FORM 5
ENVIRONMENTAL IMPACT ASSESSMENT ORDINANCE
(CHAPTER 499)
SECTION 13(1)

Application for Variation of an Environmental Permit

C2. Application No. of the Current Environmental Permit : FEP-06/129/2002/H

CADD REF. Figure 1.2 - Existing and Proposed Above-ground structures at Kwu Tung of LMC Spur Line

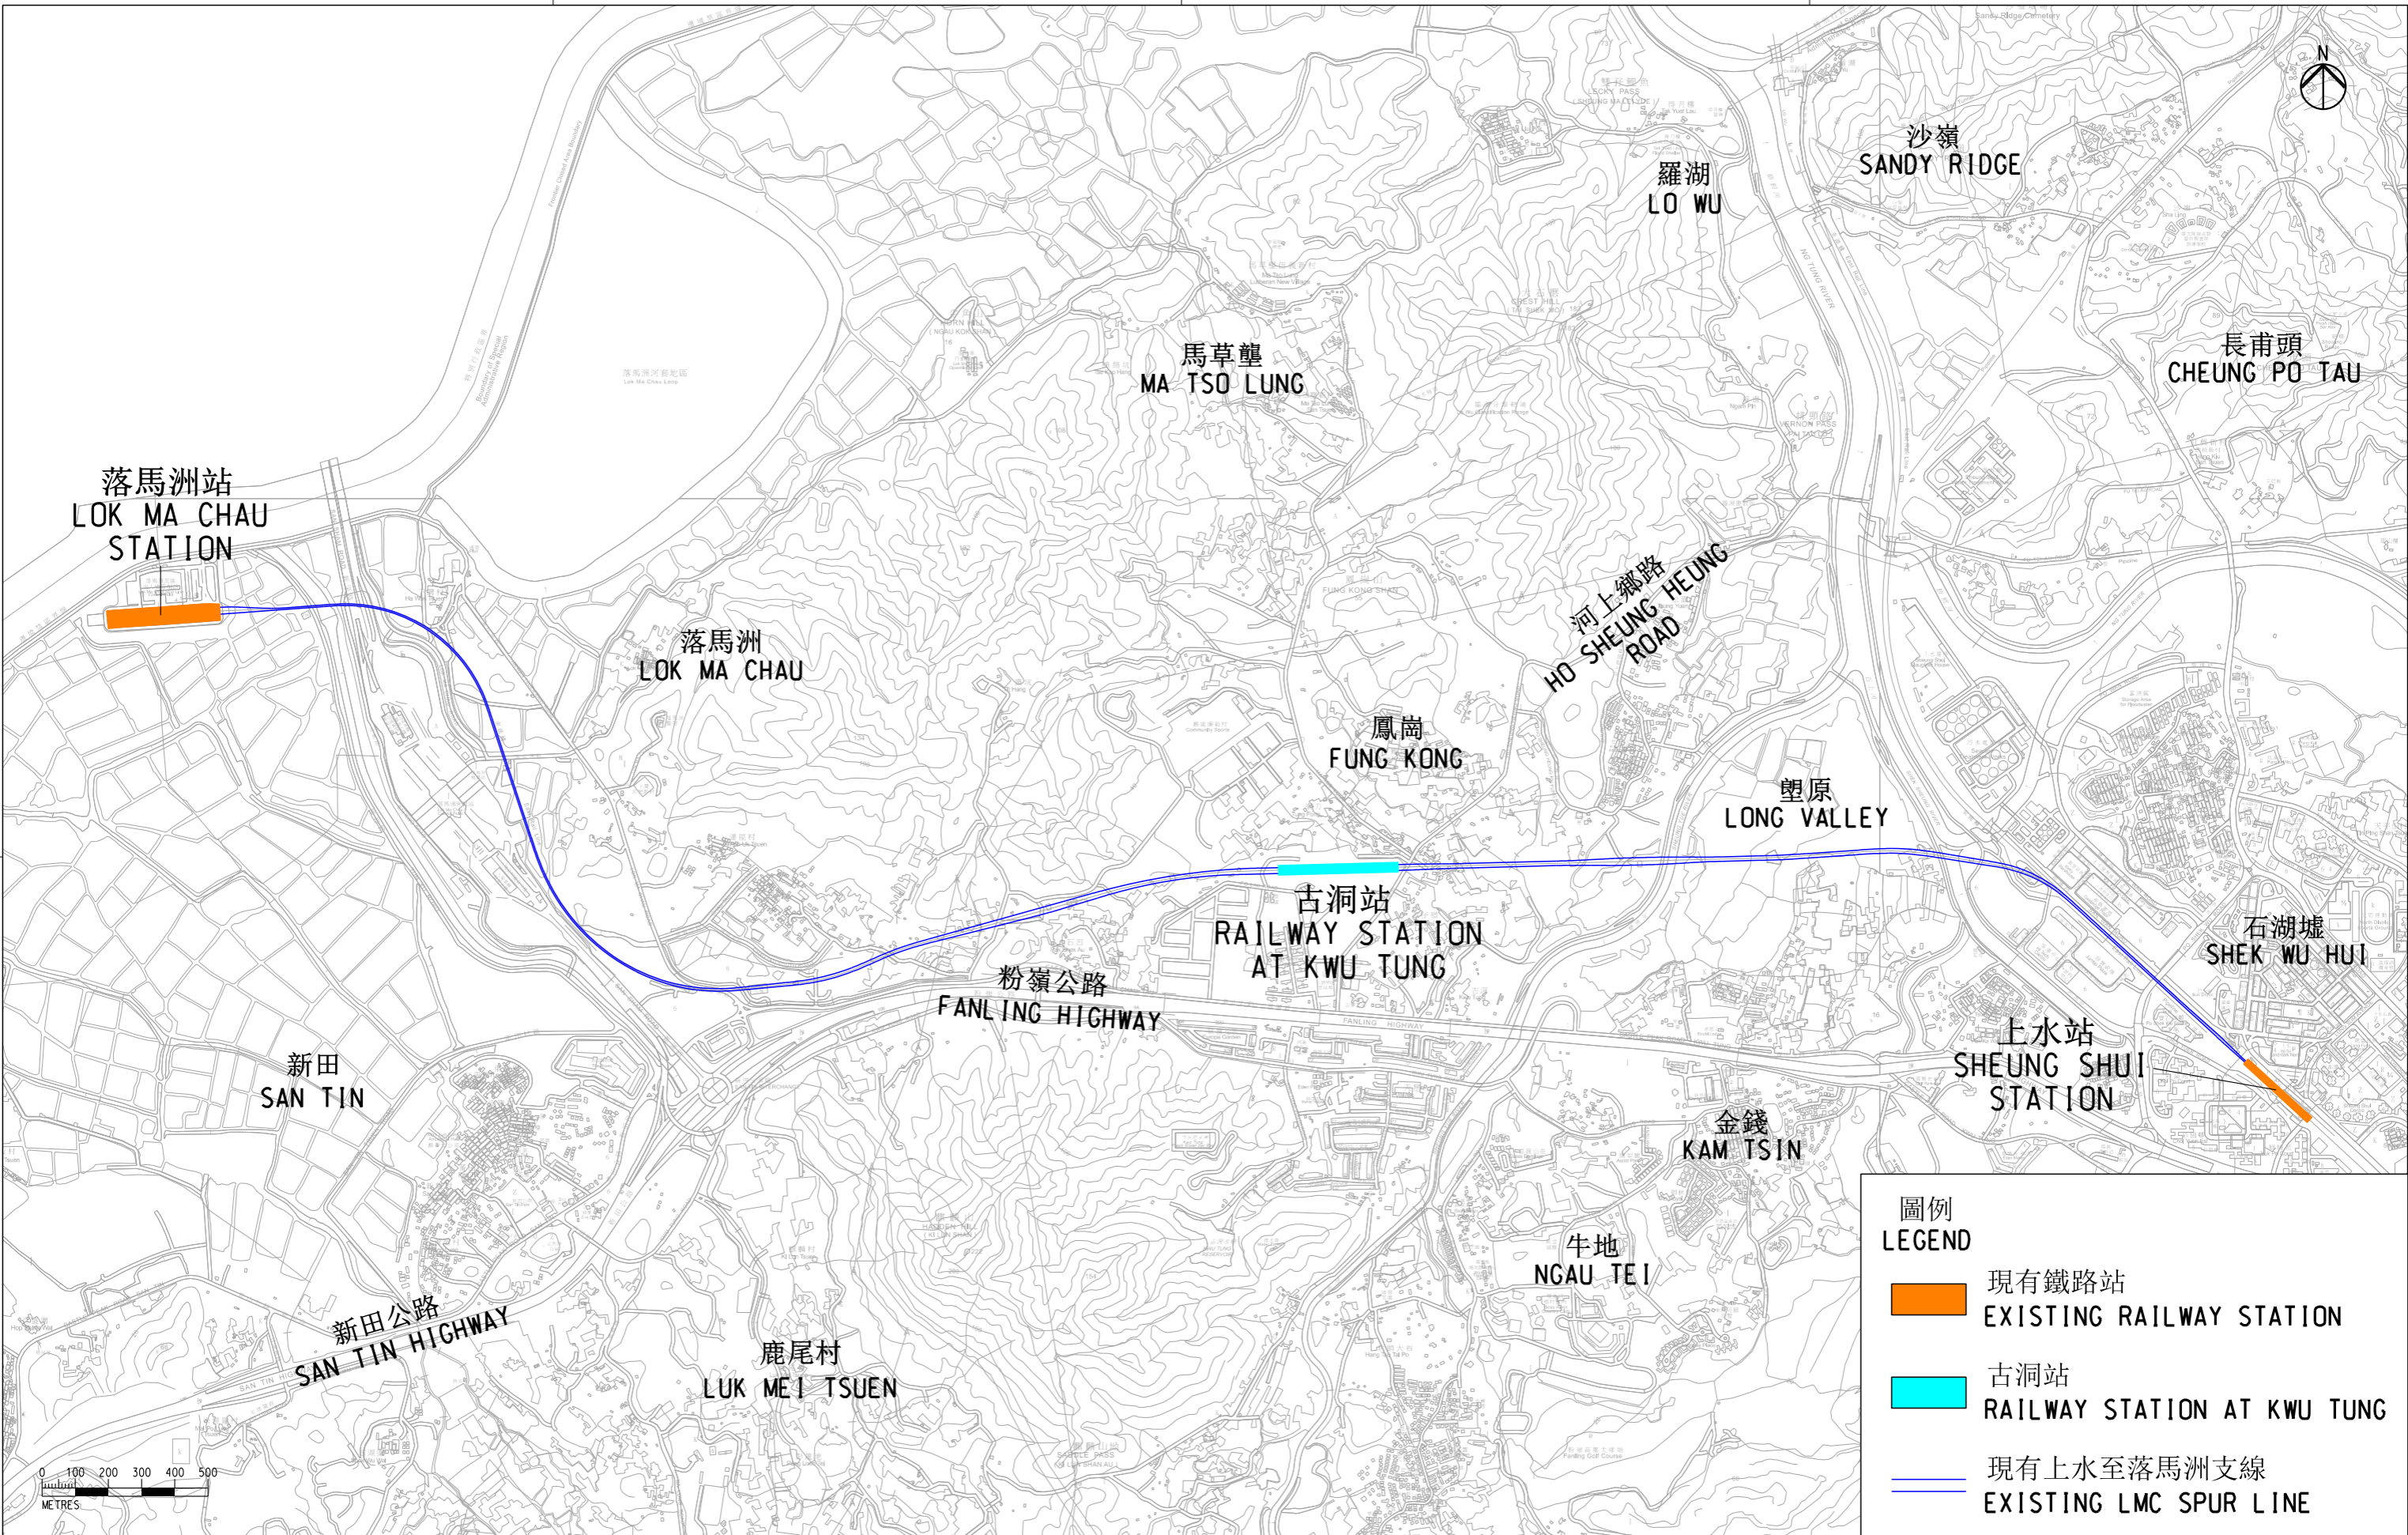
Proposed Amendments	Relevant figure/ appendix in this ERR	Relevant figure/ table/ condition to be varied in FEP-06/129/2002/H
<p>➤ Construction of railway station at Kwu Tung</p> <p>The key modifications required are given below:</p> <ul style="list-style-type: none"> • Excavation of the fill material above the existing tunnel box; • Modification of existing tunnel box structures; • Construction of concourse and platform areas; • Construction of back-of-house areas; • Construction of entrances, VB and FRS; • Modification of existing EAP/EEP; • Relocation of existing EVA and associated facilities; and • Construction of other station associated facilities and underground adit. <p>➤ Operation of railway station at Kwu Tung</p>	<ul style="list-style-type: none"> • Figure 2.1 – Location of the Project; and • Figure 2.2 – Location Plan of the railway station at Kwu Tung 	<ul style="list-style-type: none"> • Vary Part B of FEP-06/129/2002/H to include the construction and operation of the proposed railway station at Kwu Tung; • Vary Figure 1a of FEP-06/129/2002/H by Figure 2.1 in this ERR; • Add Figure 1c of FEP-06/129/2002/H by Figure 2.2 in this ERR.

As shown in **Figure 1.2**, the two existing EAP/EEPs are the existing fixed noise sources within the Project. It is also noted that there will be typical planned fixed noise sources for railway station at the proposed entrances (incorporated with VB) and proposed FRS, including ventilation fans, smoke extraction fans, chillers etc. All these noise sources would be accommodated within plant rooms with fresh air
